Agenda
Lane Cove Local Planning Panel Meeting
20 September 2022

Lane Cove Local Planning Panel Meeting 20 September 2022
60 CLIFF ROAD, NORTHWOOD.

Subject: 60 Cliff Road, Northwood.
Record No: DA21/110-01 - 38093/22
Division: Environmental Services Division
Author(s): Andrew Bland

DA Number	Council Reference: DA110/2021 – Clause 8.2 Review Portal Reference: PAN-238478
Proposed Development	Part demolition and significant alterations to the dwelling house including a rear addition, a swimming pool and related landscaping.
Street Address	60 Cliff Road, Northwood
Applicant/Owner	Applicant: Kathleen McDowell – Dickson Rothschild Owner: X Hong and O Chen
Date of DA Lodgment	5 July 2022
Development Cost	\$4,831,827.00
Public Notification Period	Notification Period: 5 July 2022 to 21 July 2022
Submissions Received	5 submissions received.
Recommendation	Approval
Local Planning Panel Referral Criteria (Schedule 1 of Planning Direction)	<ul style="list-style-type: none"> • Clause 8.2 review: The proposed application must be determined by an authority that is not subordinate the determining authority (Lane Cove Council Planning Panel) • Departure from Development Standards: Development that

Figure 5: Lower module GF plan 8.2 Review (Source: Plans from applicant)

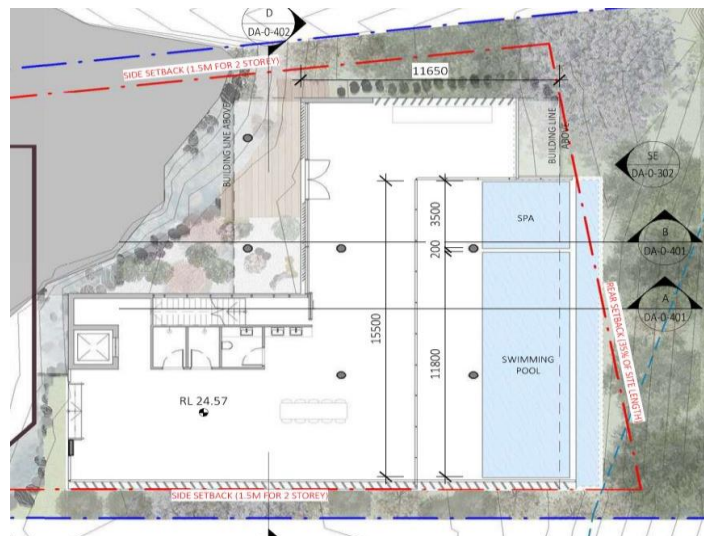
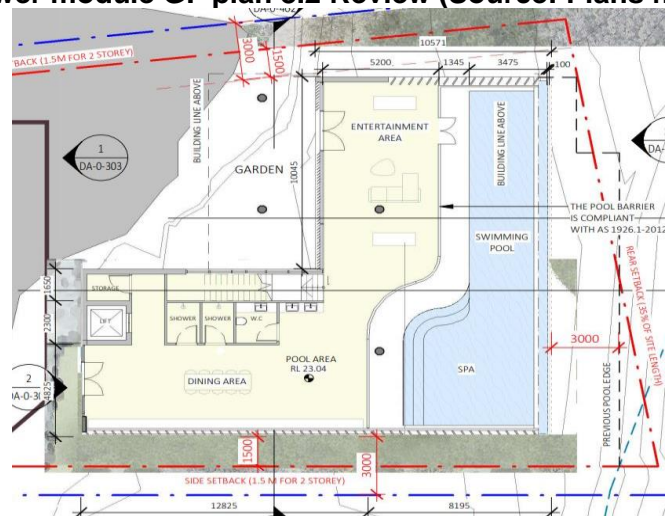
Side setbacks increased 3m from the southwest boundary and between 2.6 to 4.4m from the northeast boundary for the lower module to provide the following:

An artist impression has been provided below to contrast the original 8.2 review plans and amended proposal. See figure 3 to 6 below.

Figure 14: Proposed South-East Elevation Showing 5 Storey Appearance

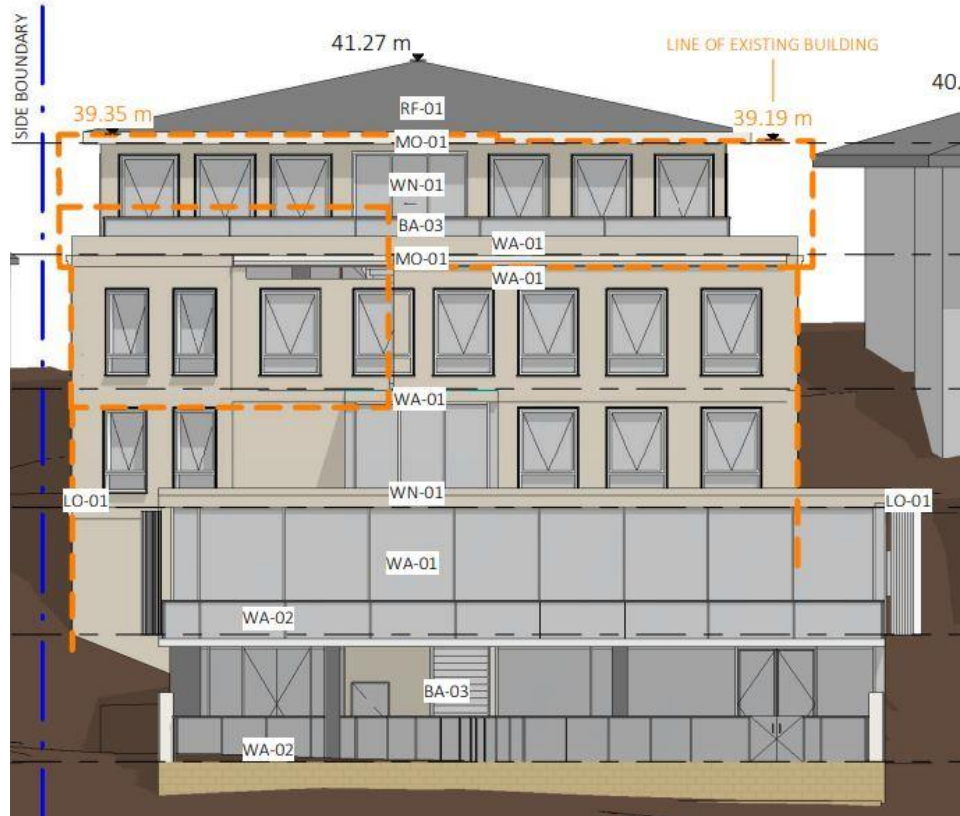
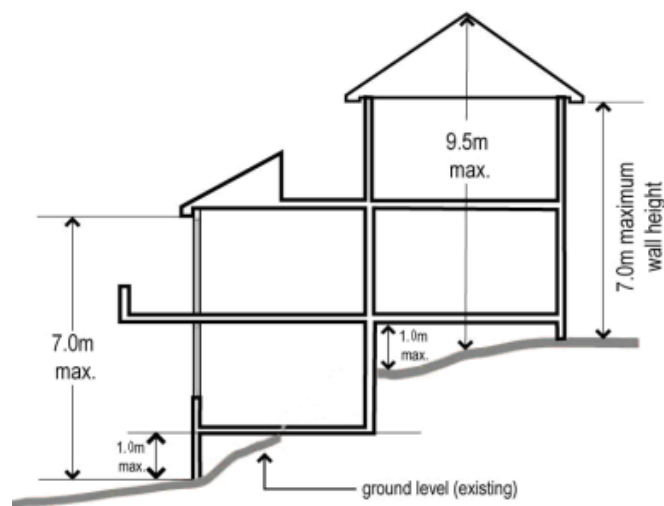
i. Maximum Number of Storeys in Elevation – Part C1.7.1(e) stipulates a maximum number of 3 storeys in appearance (in elevation) where the proposal provides up to 5 storeys in appearance (in elevation) from the foreshore as can be seen in the submitted southeast elevation drawing (four full storeys and one half storeys) as shown in **Figure 14**. In essence this limits any split-level dwelling house to two x two storey modules as per **Figure 15** below (right) to give a three storey appearance. The proposal provides three x two storey modules.

- the variation is a result of maintaining the existing undercroft area (to reduce excavation)
- the proposed development is well proportion to the street and public domain.
- the proposed development complies with the solar access provisions.
- the proposed development does not result in unreasonable view loss, refer to view loss assessment later in report.

Figure 7: Section C-C with breaches to 12m height control for TH3.

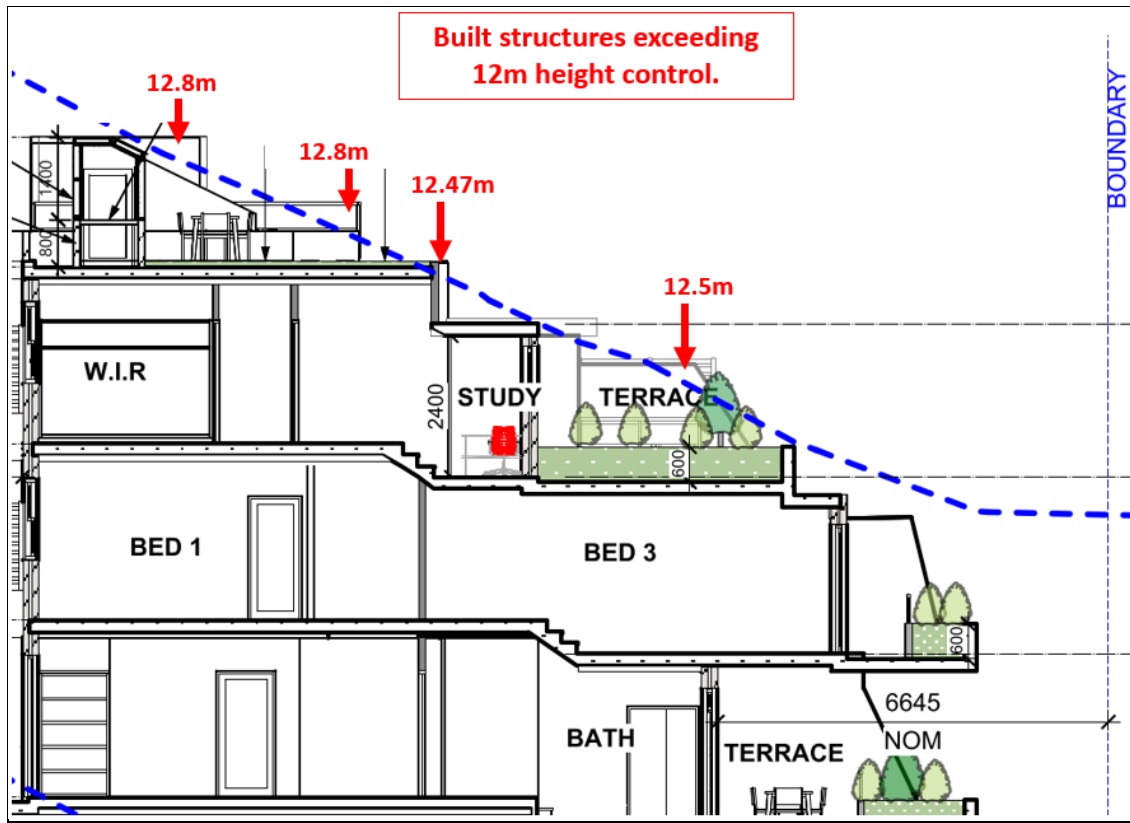
Proposed	Control	Complies
Floor Space Ratio	0.7:1	0.8:1	Yes
Height of Buildings	Section C-C of Townhouse 3 appears to have multiple breaches of the 12m height control for the roof of the ensuite of the master bedroom and roof top structures	12m	No. Approx. maximum 800mm above height control or 6.67% non-compliance. No clause 4.6 variation statement submitted.

Figure 9: Riparian Layer overlayed on Land Zoning Map LCLEP 2009.

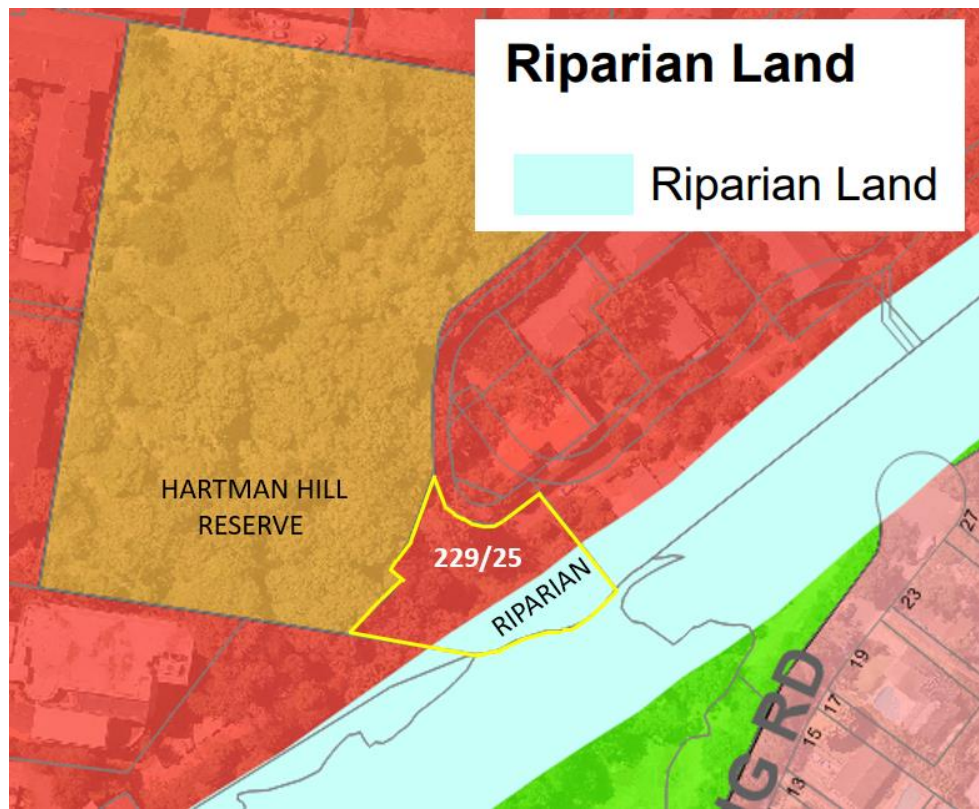
The Statement of Environmental Effects (SEE) incorrectly classifies the site as not being subject to riparian land controls. The south eastern portion of the site is classified as riparian land as it is located in proximity to Tannery Creek (refer to figures 9 and 10).

Figure 11: Stormwater plan and junction pit in SRZ.

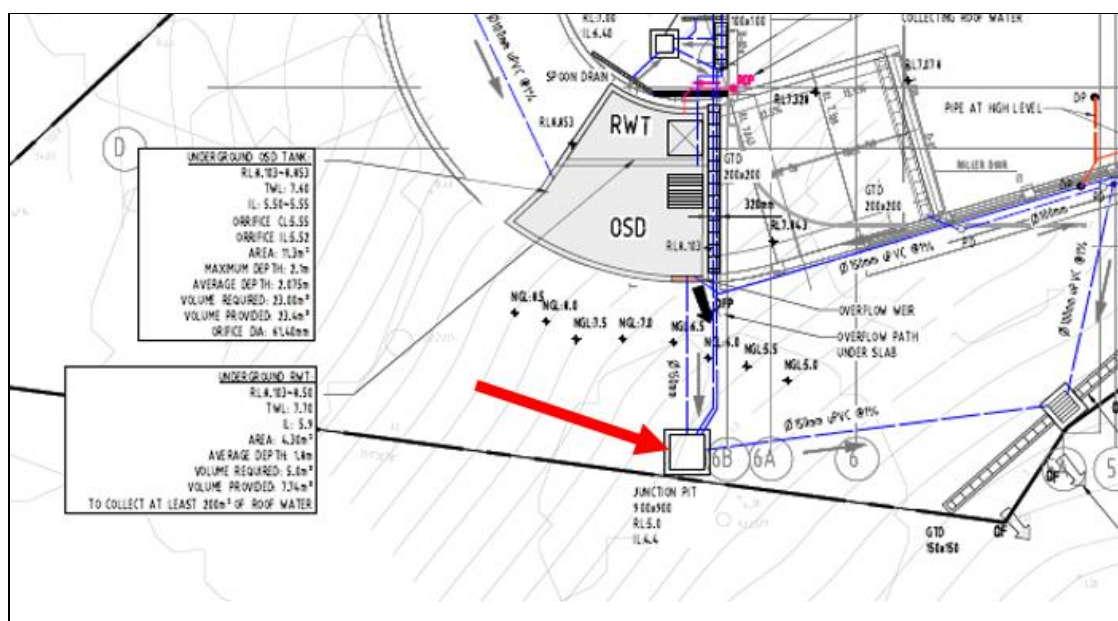
The proposal is contrary to section 5.2 (f) of Part O Stormwater Management in the Lane Cove DCP 2009 which requires stormwater infrastructure to be located away from any large trees and construction must not damage the primary root zone.

The application proposes a stormwater junction pit adjacent to a mature native tree on Council owned reserve. Refer to figure 11 below. The Stormwater Plans prepared by SGC on 25/03/2022 is positioned directly beneath Tree 27. This would have a direct impact to the root zone and overall health of Tree 27.
